Sedan Range

TECHNICAL BULLETIN

**Plenum Chamber Drain Valve –
Distorted – Water Entering ECM –
Service Action S619**

MODEL 1995 MY
XJ12 Sedan
VIN 720001-725767

ILLUSTRATION 1

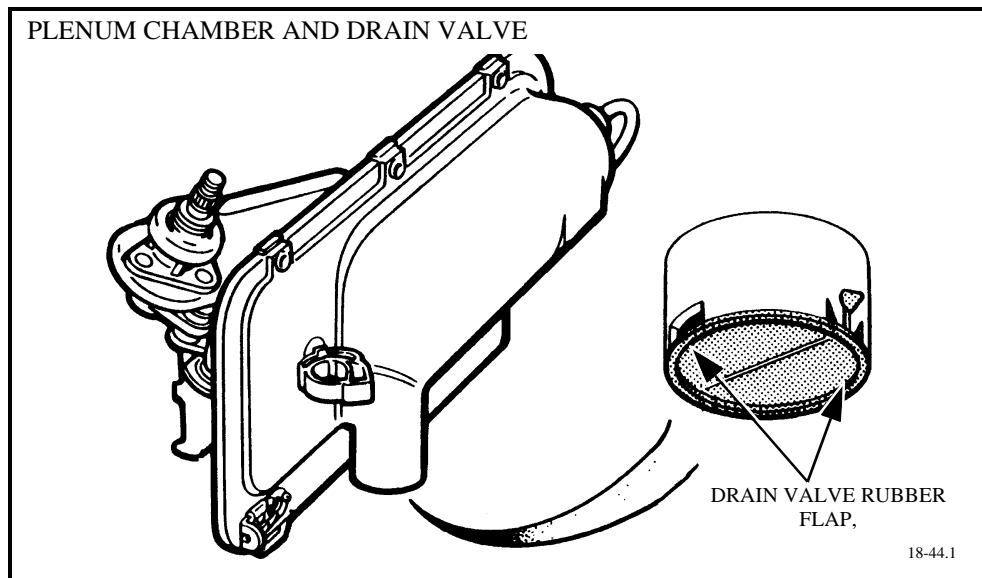
The plenum chamber water drain valve rubber flap may be incorrectly installed in some 1995 MY Sedan Range vehicles from VIN 720001 to 725767. In some cases the rubber flap may restrict the water drain tube causing water to leak down the “A” posts. The leaking water may damage the ECM.

1. Visually inspect the drain valve rubber flap using a light and mirror.
 - If the drain valve rubber flap is in the correct position, as shown in Illustration 1 above, no further action is required.

At the next service opportunity, or during PDI, check the plenum chamber drain valve rubber flap (Illustration 1) of all 1995 MY Sedan Range vehicles within the VIN range. Follow the procedure described below.

ILLUSTRATION 2

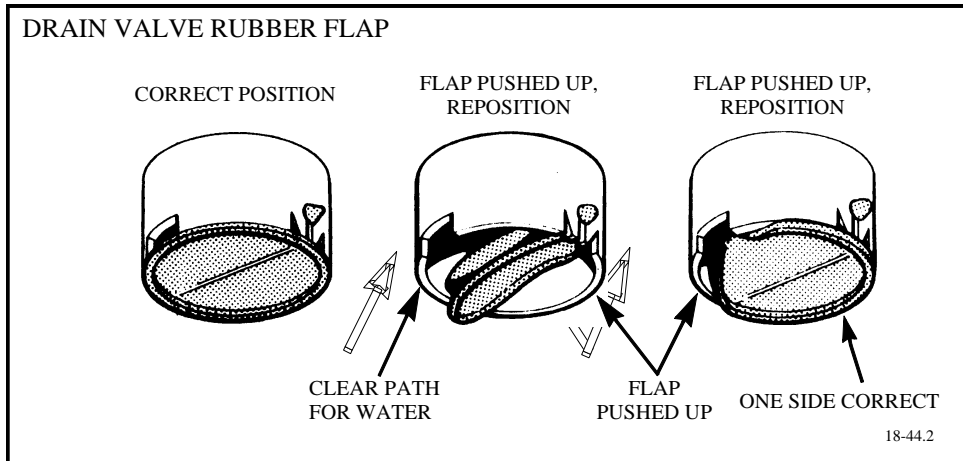
2. If the rubber flap is pushed up, with one side open to allow a clear path for water drain (Illustration 2) or with one side in the correct position, reposition the flap to the correct position with the fingers. No further action is required.

NOTE: The rubber flap must be free from the drain tube walls to allow water to drain.

ILLUSTRATION 3

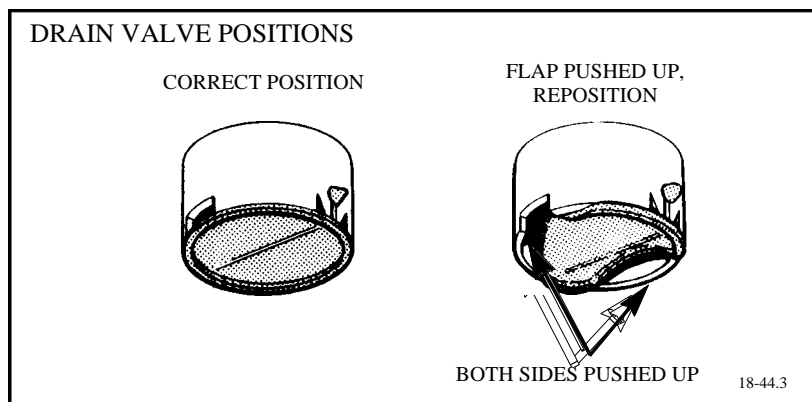
3. If the rubber flap is pushed up into the drain tube, with both sides restricting water flow (Illustration 3), reposition the flap to the correct position with the fingers and check the ECM for signs of water damage.
